Seismic Walkdown Checklist (SWC)

Equipment ID No. I-1605-95-SPB Equip. Class¹² ZO

Equipment Description SOLID STATE PROT SYS CAR-TEN B

Location: Bldg. CONTROL Floor El. 220 Room, Area 165

Equipment ID No. 1-1804-S3-A02 Equip. Class¹² 3 (Medium Voltage Switchgear)
 Equipment Description 4160 V Switchgear 1AA02

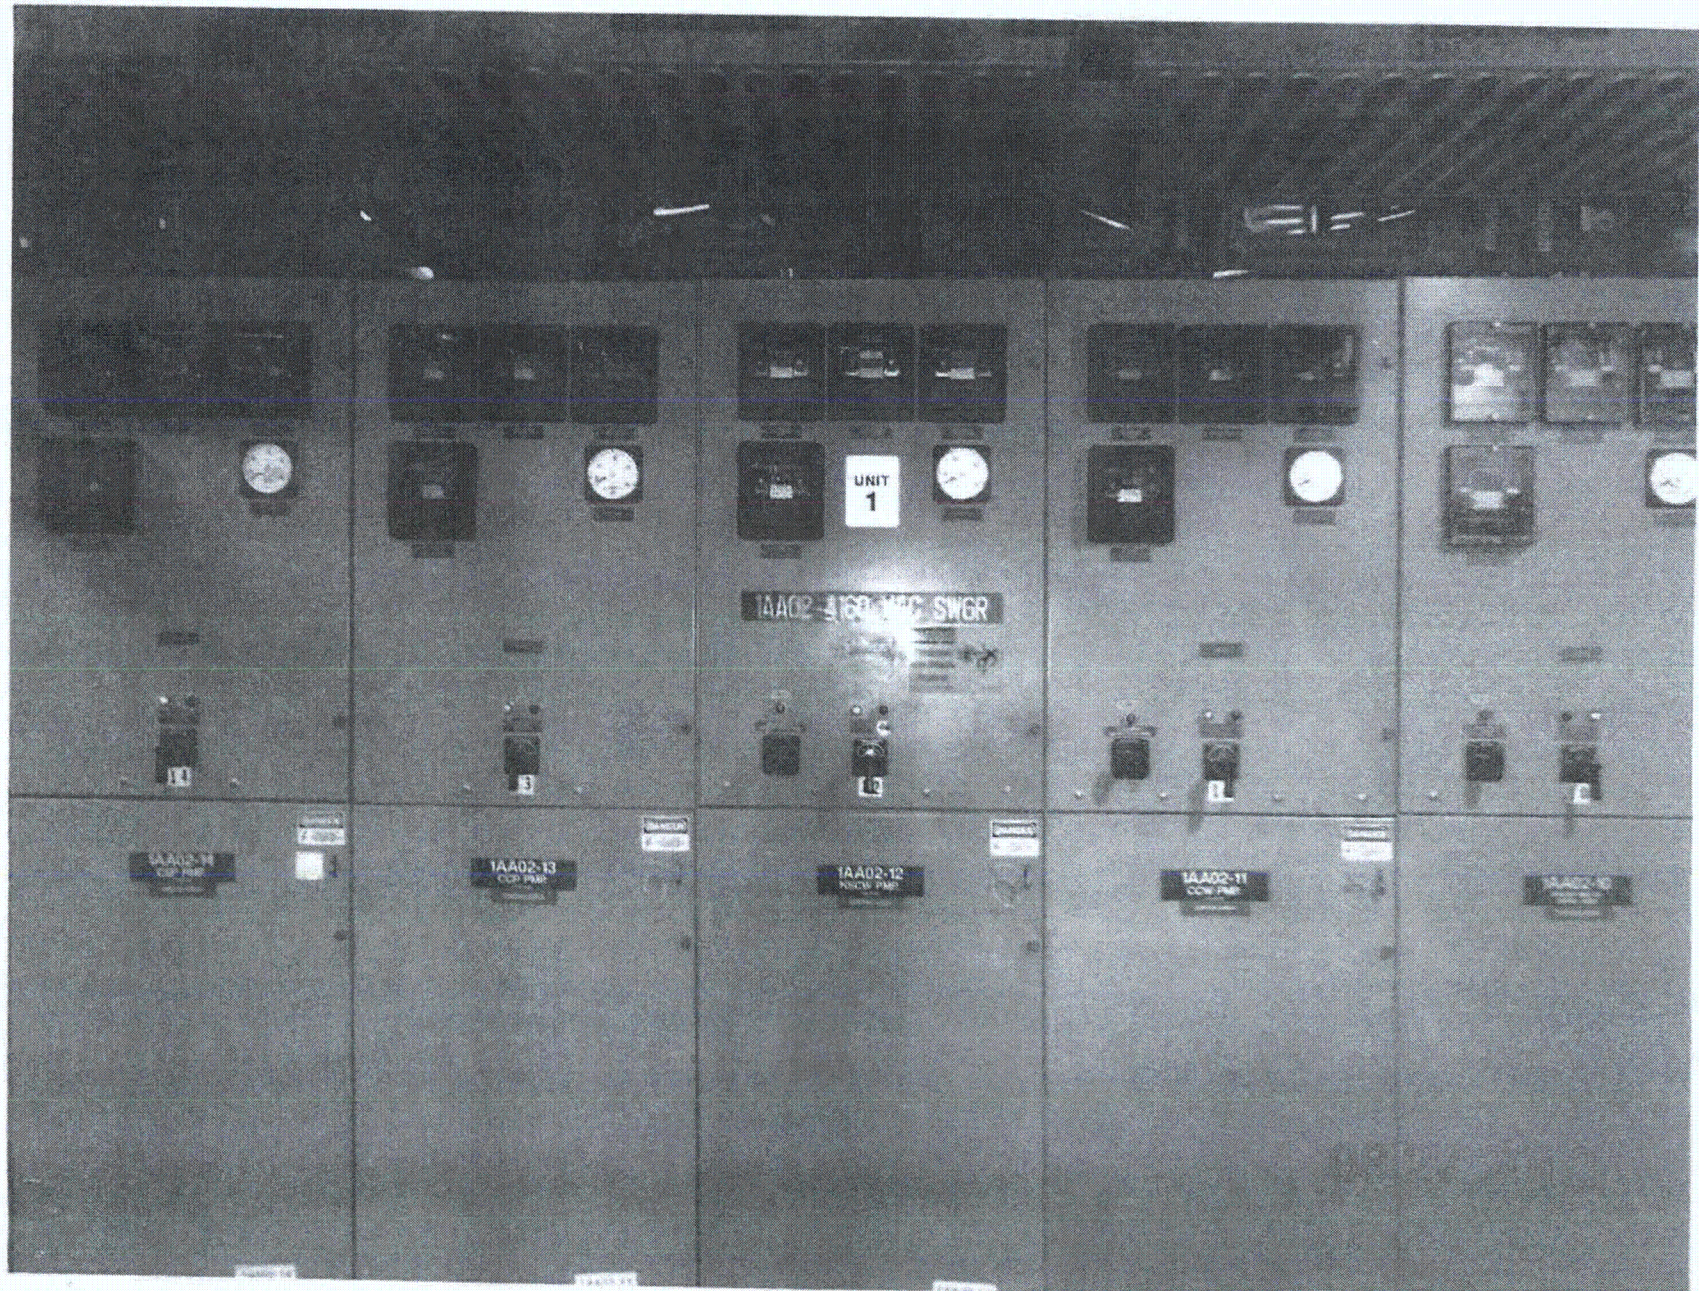
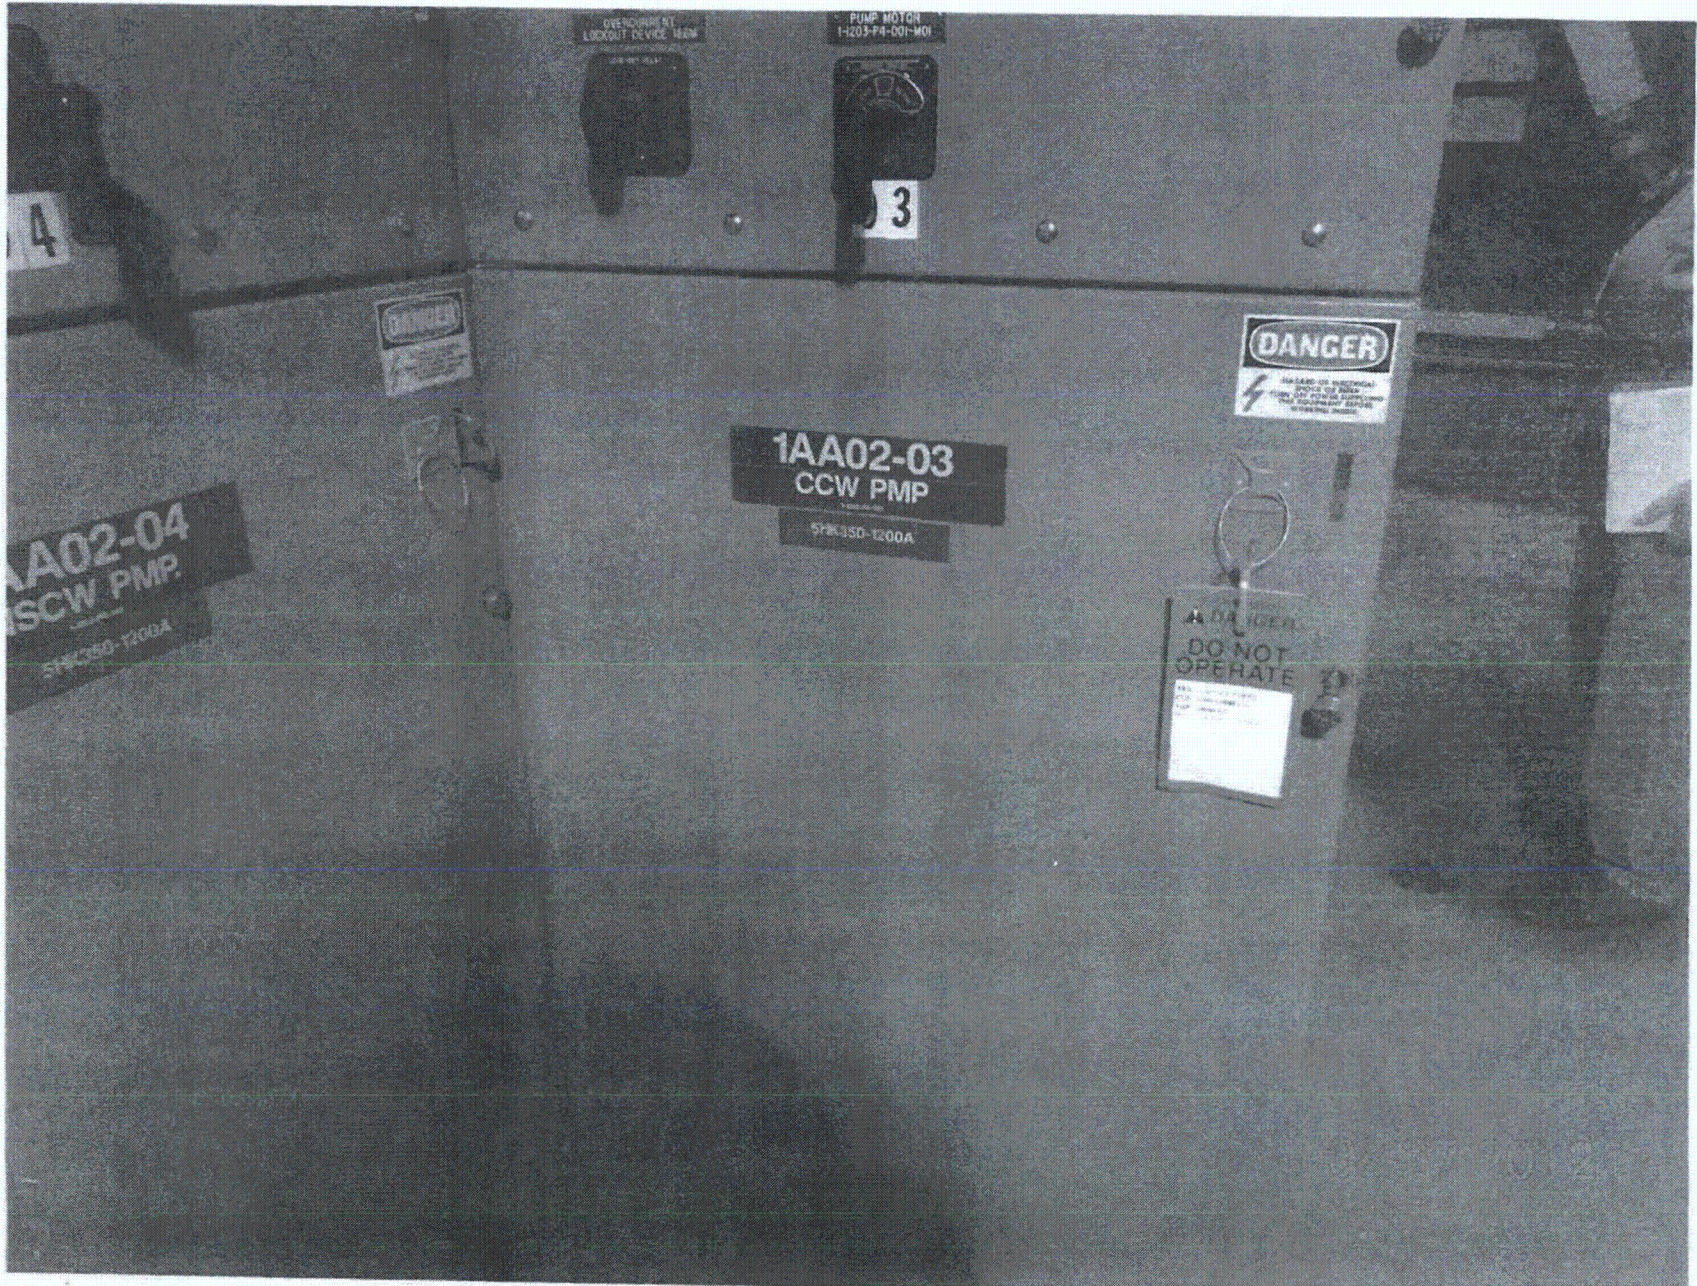
- 9. Do attached lines have adequate flexibility to avoid damage? Y N U N/A
 2 ductwork extensions from the top of the cabinet appear to be rigidly connected at bays 1AA02-01 and -05. Refer to CR 517078.

Comment 1: SEE 1-1623-DS-006A FOR AREA WALK-BY CHECKLIST (AWC).
 Comment 2: Visual inspection of all front welds except bays 1AA02-00 and -02 was performed. Full inspection of 1AA02-03 was performed (front, rear, plug, fillet). Based on the number and good condition of inspected welds, the anchorage of the panel is determined to be acceptable. Full inspection of the anchorage is required during an outage. MWD 8/27/12

9. Do attached lines have adequate flexibility to avoid damage? Y N U N/A
 A condition report 517078 was generated for a possible case of a rigid connection on the SWC dated on 8/27/12. Technical Evaluation 519183 resulted as a related record of the condition report to investigate this possible condition. The technical evaluation was resolved on 10/22/12 resulting in a no rigid connection case. *Jose R. Hernandez 10/23/12*

① By performing the internal inspection of this cabinet, the welds referred on comment 2 of the SWC dated on 8/27/12 it was possible to complete the anchorage verification on this component. No adverse conditions were found and the anchorage configuration is consistent with the plant configuration.
